This AD is required because TRFs, part numbers 340-166-205-0, 340-166-206-0, 340-166-207-0, 340-166-208-0, 340-166-209-0, 340-166-210-0, now require an initial inspection threshold of 25,000 cycles-in-service (CIS) on the commercial (air carrier) models engines and 19,000 CIS on the business jet models. This proposed AD would not affect any other CFM56-7B part number TRFs. We have been monitoring CFM's revised life analysis progress since February 2005. CFM International provided to us the November 15, 2006 revision to the ESM to introduce mandatory inspections of the TRF. CFM International has been using a damage tolerant lifing approach, based on an FAA approved methodology for structural lifed components, to prepare life extensions for all CFM56 TRFs using on-condition life management. This improved life management process defines a first inspection threshold and reinspection intervals accounting for crack initiation and propagation. The previous life management process was based on crack initiation only. This condition, if not corrected, could result in failure of the TRF from low-cycle fatigue cracks. Failure of the TRF could result in engine separation from the airplane, whic

Figure 805,

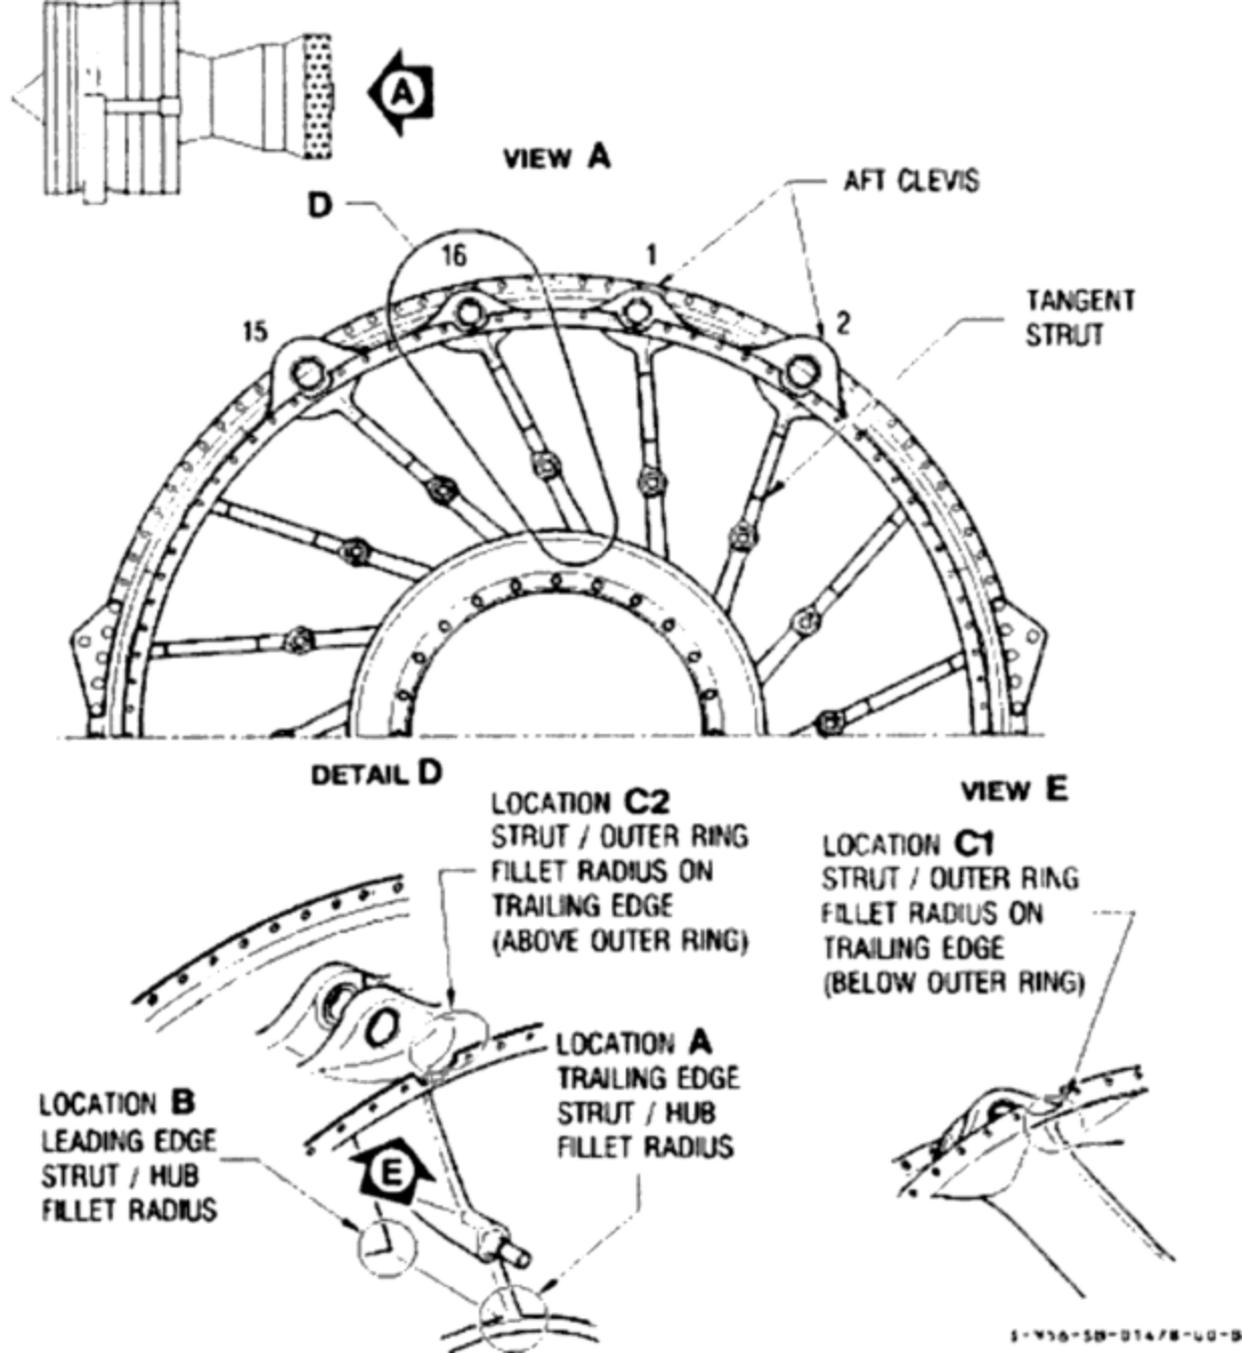
2. Mandatory Inspection Intervals for the Critical Areas of the Turbine Rear Frame with Tangential Struts (4 Mount Struts, No. 1, 2, 15, and 16).

C. Turbine Rear Frame Part Numbers 340-166-205-0, 340-166-206-0, 340-166-207-0, 340-166-208-0, 340-166-209-0, 340-166-210-0, for all CFM56-7B SAC engine models (except -7B27A engine models). Refer to figure 805.

Figure index No.	Inspection location	Inspection threshold (cycles since new)	Inspection intervals (cycles)	Inspection reference
805	Strut/outer ring fillet radius on trailing edge (A)	25,000* for -7B SAC (except business jet) engine models	Refer to Figure 806* for -7B SAC commercial applications	Refer to SB 72-0579*.
	Strut/outer ring fillet radius on leading edge (B)	19,000* for -7B SAC business jet engine models	Refer to Figure 807* for -7B SAC business jet applications	
	Strut/outer ring fillet radius on trailing edge (C1 below outer ring)			
	Strut/outer ring fillet radius on trailing edge (C2 above outer ring)

Note: Applicable to all inspection locations. If inspection is not performed, part must be removed.*

(f) Within the next 30 days after the effective date of this AD, revise the applicable inspection program for the Business Jet and Air Carrier engine models by adding the Mandatory Inspection Intervals as specified in this AD, and revise the Airworthiness Limitations Section (chapter 05-21-03) of the CFM56-7B Engine Shop Manual, CFMI-TP-SM.10 by adding the following:
